Serial No.: 19-260  
NRA/DEA: R3  
Docket Nos.: 50-280/281  
License Nos.: DPR-32/37

**VIRGINIA ELECTRIC AND POWER COMPANY**  
**SURRY POWER STATION (SPS) UNITS 1 AND 2**  
**SUBSEQUENT LICENSE RENEWAL APPLICATION**  
**RESPONSE TO REQUESTS FOR ADDITIONAL INFORMATION – SET 2**

**RESPONSE TO REQUESTS FOR ADDITIONAL INFORMATION**  
**SET 2 REGARDING SPS SLRA**

Figure 1 (Extracted from ETE-SLR-2018-1271)

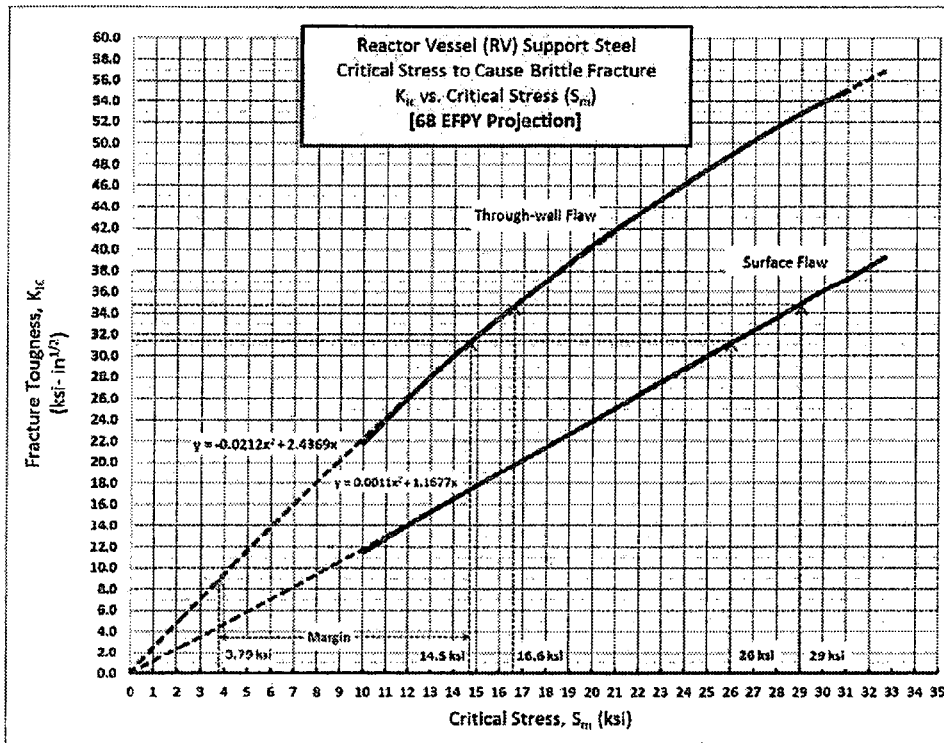
Due to lack of guidance for assessment of the embrittlement of the reactor vessel supports, it is recognized that utilization of the methods outlined in NUREG-1509, the 1986 Project Topical Report, and ETE-SLR-2018-1271 contains a level of uncertainty. The Dominion assessment outlined in the 1986 Project Topical Report and ETE-SLR-2018-1271 uses fracture mechanics formulas (consistent with those provided in ASME Boiler & Pressure Vessel Code, 2013 Edition, Section XI, "Rules for Inservice Inspection of Nuclear Power Plant Components," Appendix A) to demonstrate that a postulated surface flaw and postulated through wall flaw are stable based on a lower bound fracture toughness  $K_{IR}$  curve (i.e.  $K_I < K_{IR}$ ), and does not propagate in an unstable behavior (i.e. brittle fracture). The assessment is performed by re-arranging the stress intensity factor formulas to back calculate the critical stress corresponding to when brittle fracture would occur. The results of the fracture mechanics evaluation from ETE-SLR-2018-1271 is shown in Figure 1.

During discussions with NRC it was recognized that application and quantification of ASME code margins (consistent with structural margins in Section XI, IWB-3600) or use of a bounding analysis would be helpful. In response to this recognition, Dominion has used a safety margin of  $\sqrt{2}$  on  $K_{IR}$  fracture toughness based on ASME Code, Section XI, IWB-3600 (note that  $K_{IR}$  and  $K_{IA}$  from ASME Code, Section XI, Appendix A-4200 are synonymous). Moreover, as an additional conservatism, the lower bound  $K_{IR}$  value of 26.7 ksi $\sqrt{\text{in}}$  from the ASME Code is used to determine the critical stress. This critical stress is back-calculated for a 1/4T postulated surface flaw and a postulated through wall flaw per the linear elastic fracture mechanics methodology as discussed in the 1986 Project Topical Report and ETE-SLR-2018-1271. If the design basis actual stresses are below the critical stresses, then the critical regions of the NST are protected against brittle fracture.

Figure 2 Fracture Toughness  $K_{IR}$  and  $K_{IC}$

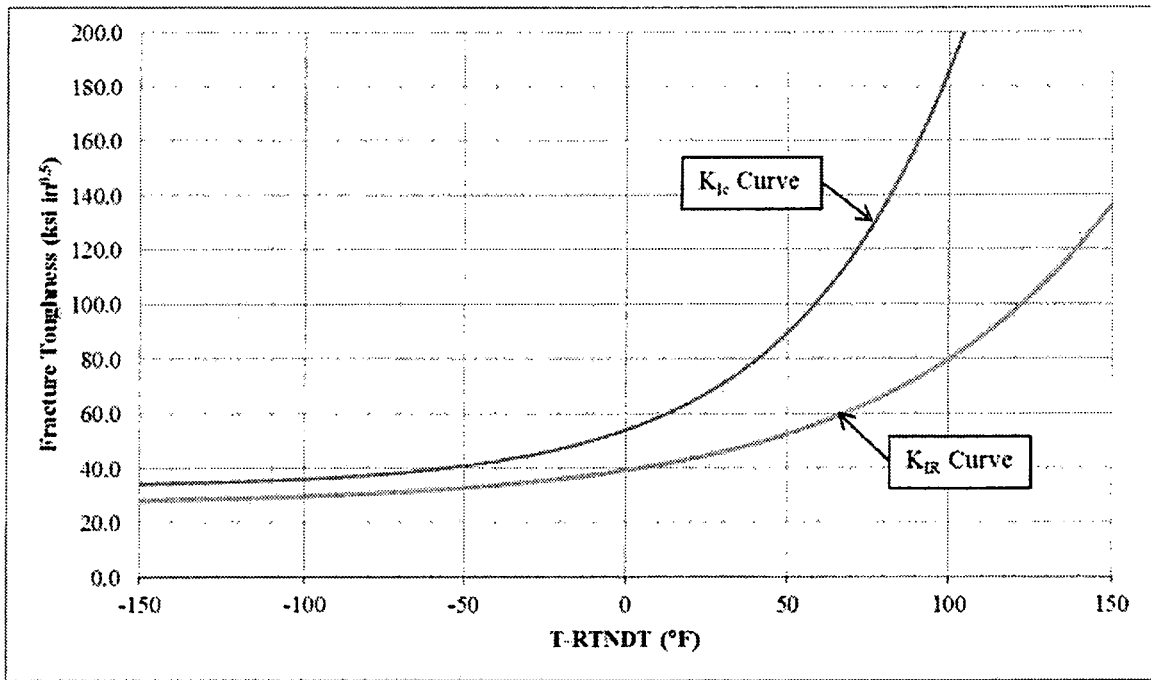
The sensitivity assessment shown below is based upon the lower bound  $K_{IR}$  value of 26.7 ksi $\sqrt{\text{in}}$  which accounts for an infinite amount of embrittlement shift in material properties. In other words, the value of 26.7 ksi $\sqrt{\text{in}}$  is the lowest value  $K_{IR}$  can reach when the value of  $T-RT_{NDT}$  is very low (as shown in Figure 2), assuming a very high embrittlement and a large shift in  $RT_{NDT}$  based on NUREG-1509, Figure 3-1.

Figure 3 Sensitivity Assessment (  $K_{IR}/\sqrt{2}$  )

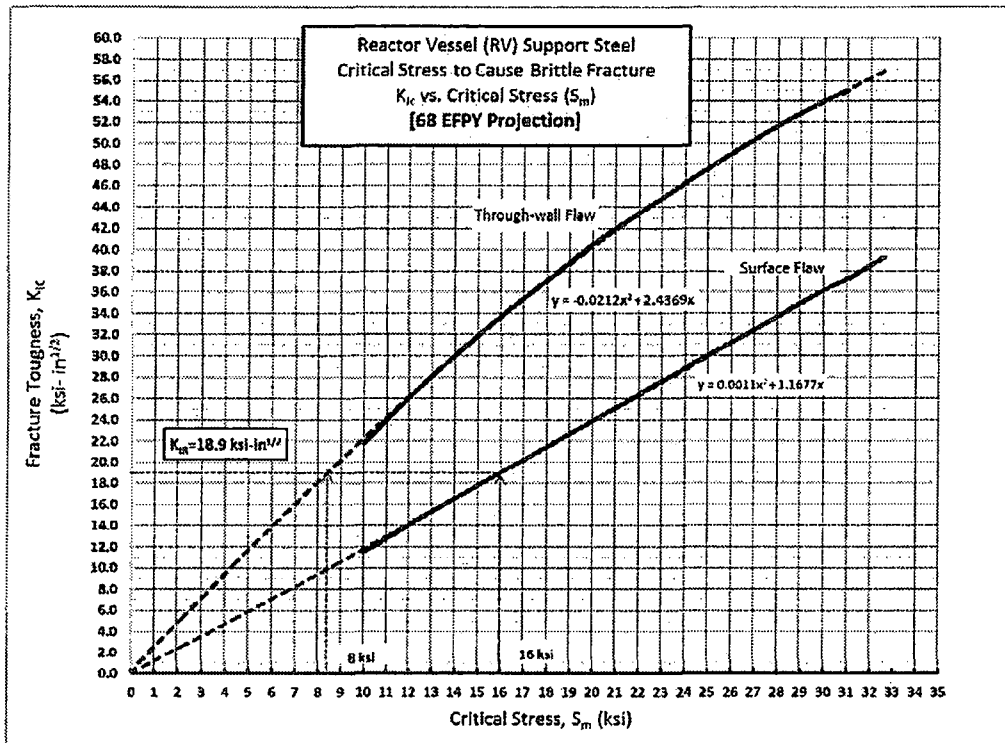
Incorporating a safety margin based on IWB-3600, gives  $K_{IR}/\sqrt{2} = 18.9 \text{ ksi}\sqrt{\text{in}}$ . Based on Figure 3 below, for  $K_{IR}/\sqrt{2} = 18.9 \text{ ksi}\sqrt{\text{in}}$ , the postulated through-wall flaw has a  $S_m$  that is approximately 8 ksi, while for the surface flaw, the  $S_m$  is approximately 16 ksi. These above mentioned  $S_m$  values are larger than the applied tensile stresses from Table 1 (6.31 ksi) and from Table 2 (6.28 ksi) of ETE-SLR-2018-1271 for both the postulated through-wall flaw and the postulated 1/4T surface flaw, respectively.

Thus, the RV supports are acceptable even if a lower bound  $K_{IR}$  of 26.7 ksi $\sqrt{\text{in}}$  is considered with incorporation of safety margins from IWB-3600. Therefore, the neutron shield tank will maintain structural integrity throughout its lifetime (even past 80 years of operation, if the design basis stress stays below the critical stresses) since it is not possible to experience neutron damage in excess of that illustrated by the lower bound  $K_{IR}$  value.

Per Figure 3, based upon the lower bound  $K_{IR}$  value of 18.9 ksi $\sqrt{\text{in}}$ , which includes the safety margin of  $\sqrt{2}$ , the calculated critical (allowable) stresses for a through-wall flaw and surface flaw are approximately 8 ksi and 16 ksi, respectively. These  $S_m$  values are larger than the applied tensile stresses from Table 1 (6.31 ksi) and from Table 2

Figure 1: 2019 Edition ASME Section XI Figure C-4210-1

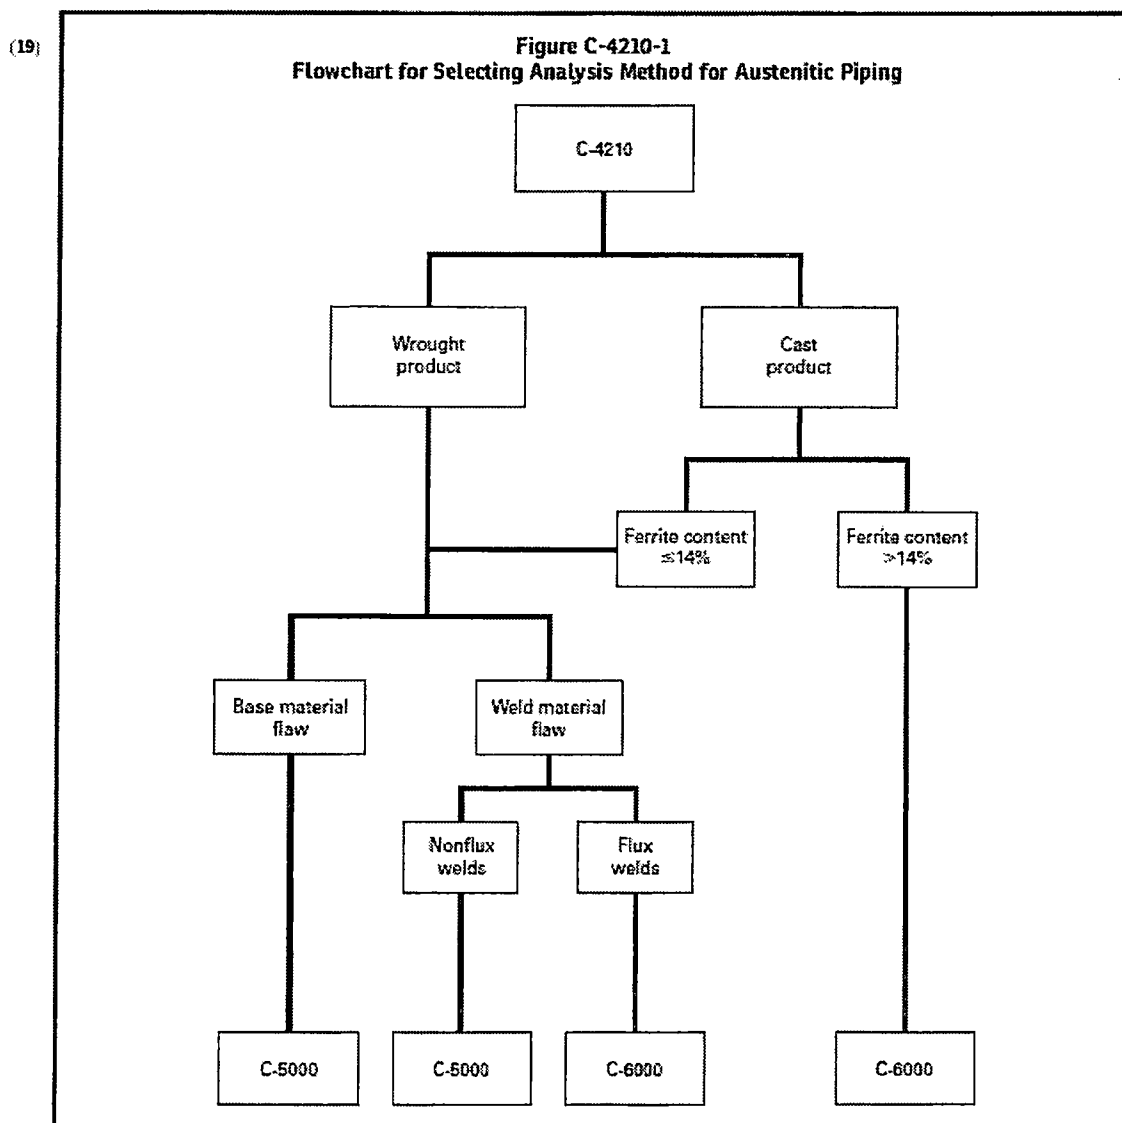
There are no flaw evaluation guidelines for CASS piping with delta ferrite content equal to or greater than 20% (as shown in Figure C-4210-1 of Appendix C) up to the current 2017 Edition of ASME Code, Section XI Appendix C. Over the last three years, the ASME Code Working Group on Pipe Flaw Evaluation had been developing a basis to update Appendix C and Figure C-4210-1 to provide guidance for CASS materials with different levels of delta ferrite content. The 2019 Edition of the ASME Code, which is scheduled to be published in July 2019, has updated Appendix C and Figure C-4210-1 (see Figure 1 herein) for use of limit load with SAW Z-factors for delta ferrite levels greater than 14% but less than or equal to 25%. For ferrite levels below 14%, limit load is sufficient with no use of Z-factors, while for ferrite levels greater than 25%, the flaw

] <sup>a,c,e</sup> the flaw evaluation per limit load methodology with Z-factors based on SAW per ASME Code, Section XI Appendix C is acceptable as the latest 2019 Edition has updated Figure C-4210-1 and the guidance for CASS piping with delta ferrite greater than 20%.

Thus, two separate ASME approved and NRC reviewed methodologies are provided (Code Case N-838 and 2019 Edition of ASME), which demonstrate acceptability of Units 1 and 2 CASS piping for those materials that have delta ferrite values larger than 20% [ ]<sup>a,c,e</sup> As a result, the CASS piping/elbows in the main loop piping demonstrates sufficient fracture toughness and flaw tolerance for operation up to 80 years.

Figure 2: PVP2017-66100, Figures 10 and 11

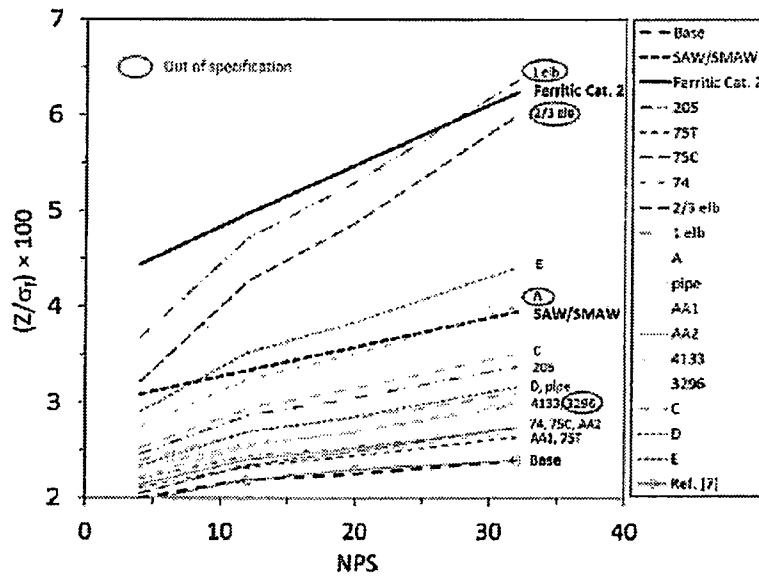
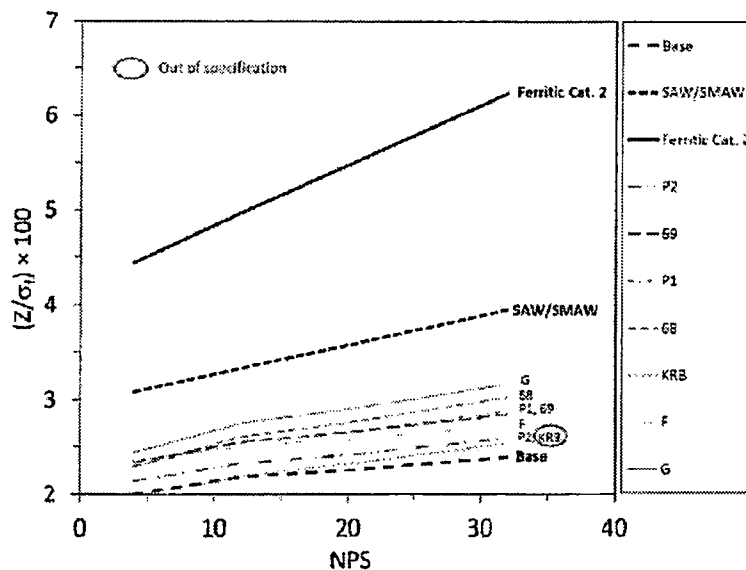
Based on PVP2017-66100, which forms the technical basis for the 2019 Edition of ASME Section XI Appendix C changes, two data plots can be used to summarize the background of the methodology updates. Figures 10 and 11 from PVP2017-66100 (shown in Figure 2 herein) compares the normalized Z-factor to flow strength as a function of nominal pipe sizes for Grade CF8M and CF3/CF8 CASS materials. For the development of the technical basis in PVP2017-66100, normalized Z-factor is used because the experimental data had varying degrees of flow stress; therefore, a more accurate comparison of the normalized Z-factor is employed in the PVP paper. Also shown in Figures 10 and 11 of PVP2017-66100 are the Z-factors for wrought stainless steel (base metal), Submerged Arc Weld (SAW) / Shielded Metal Arc Weld (SMAW) and the ferritic steel Category 2 piping material in ASME Code, Section XI.

Based on Figure 10 of PVP2017-66100 for Grade CF8M, it is demonstrated that the normalized Z-factor for the two data points which falls between 0 and 14% ferrite content (Heat IDs AA1 and AA2, see PVP2017-66100) are very close to the wrought stainless steel, thereby confirming that Grade CF8M CASS in this delta ferrite content range can be treated as wrought stainless steel. The seven data points between 14% and 25% (Heat IDs D, Pipe, 74, 75C, 75T, 205 and 4133) all have normalized Z-factors that are less than the corresponding normalized Z-factors for the SAW/SMAW material, thereby justifying the conservative use of the Z-factor for the SAW/SMAW material for Grade CF8M CASS piping with delta ferrite content in the 14% to 25% range. It can also be seen that the remaining six data points (Heat IDs A, C, E, 1ELB, 2/3ELB and 3296) with delta ferrite contents greater than 25% have normalized Z-factors that are below

For Grades CF3/CF8, it can be seen from Figure 11 of PVP2017-66100 that normalized Z-factors for the two data points with ferrite content less than 14% (Heat P2 and F) are very close to that of the wrought base metal which indicates that delta ferrite content in this range can also be treated as the wrought base metal. All other heats with delta ferrite content greater than 14% have normalized Z-factors which are fairly above that for the wrought base metal but less than that for the SAW/SMAW and, as such, it is conservative to use the criteria for the SAW/SMAW presently in the ASME Code for these CASS Grades for delta ferrite content greater than 14%.

Figure 2: Figure 6-6 from WCAP-18258

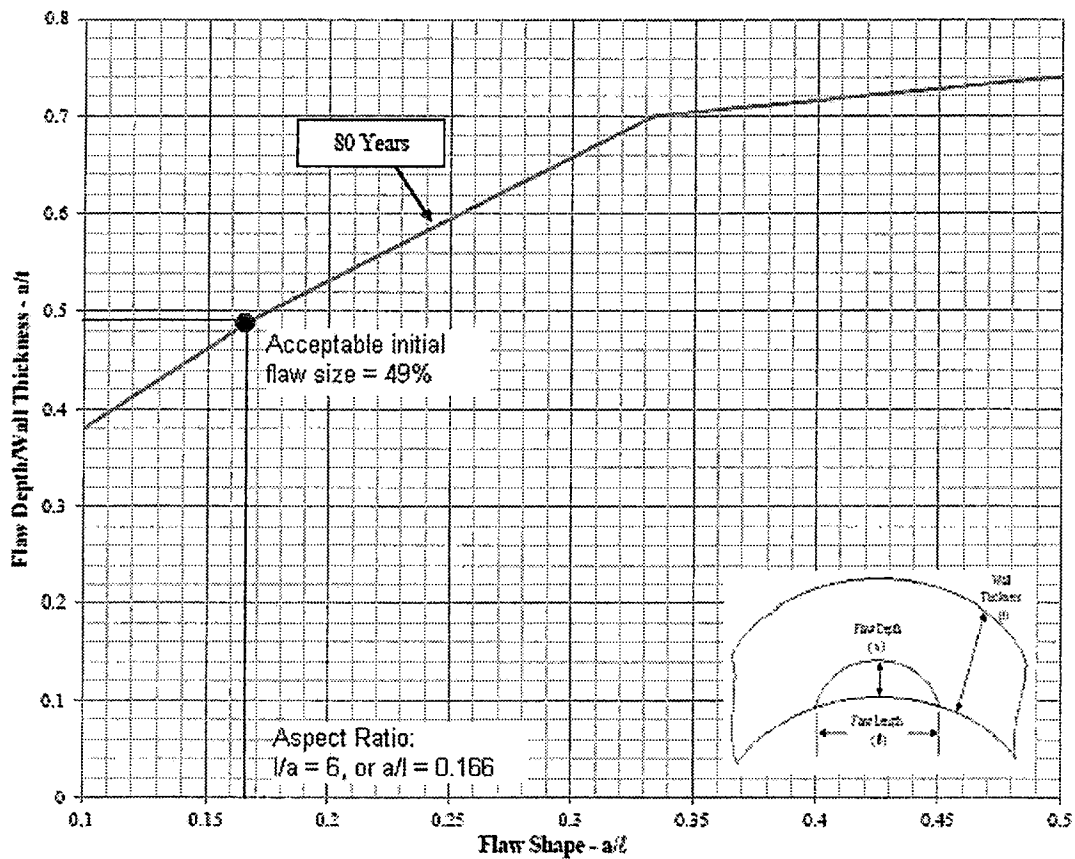
Discuss assessment of the cold leg circumferential flaw information in Table 6-1 and Figure 6-6 of WCAP-18258.

Using Figure 6-6 (see Figure 2 below) as an example for explanation purposes; the chart is for postulated circumferential flaws in the cold leg. Table 6-1 (see Figure 1 below) shows supplemental information for explanation since it contains numerical values. The information in Table 6-1 is for an aspect ratio of  $l/a = 6$  (or  $a/l = 0.1666$ ), an aspect ratio of 6 is picked because it is a common flaw case used throughout the industry for fracture mechanics assessment and evaluation.

Figure 6-6, includes a single blue curve labeled as 80 years. This curve was constructed by first determining the maximum allowable end of evaluation flaw size. The maximum end-of-evaluation flaw size is not shown on the curve in Figure 6-6. However, in Table 6-1, the maximum end-of-evaluation flaw size for AR (aspect ratio) = 6 is 50% ( $a/t$ ) of the wall thickness. The maximum allowable end of evaluation flaw size of 50% is based on limit load analysis per ASME Section XI App C. This flaw size is calculated based on plastic collapse and is also frequently called the critical flaw size. The circumferential maximum allowable end of evaluation flaw sizes is based upon dead weight, pressure, thermal expansion, seismic, and LOCA loads (see Table 2-2 of WCAP-18258). The maximum allowable end of evaluation flaw size is the largest final flaw size for which the pipe can theoretically fail based on ASME Section XI guidance.

The blue curve of Figure 6-6, plotted for  $a/l = 0.166$  (AR = 6:1), shows the acceptable initial flaw size = 49%. This value of 49% of the wall thickness is also presented in Table 6-1 as the acceptable initial flaw size. Therefore, this case demonstrates that the cold leg piping can tolerate a flaw size of 49% of the wall thickness for 80 years for AR = 6. Any flaws with AR = 6 that are less than 49% of the wall thickness are acceptable for 80 years. Similar to AR = 6, the blue curve is composed of other aspect ratios ranging from 2 to 10, and the calculated acceptable initial flaw sizes are graphically illustrated on Figure 6-6. Any flaw sizes that fall below the blue curve on Figure 6-6 are acceptable for 80 years based on ASME Section XI, and any flaws above the blue curve are unacceptable. As a concluding remark in Table 6-1, the difference between the acceptable initial flaw size and the maximum allowable end of evaluation flaw sizes is the amount of crack growth in 80 years. For the case of AR = 6 for the cold leg circumferential flaw, the growth is only 1%.
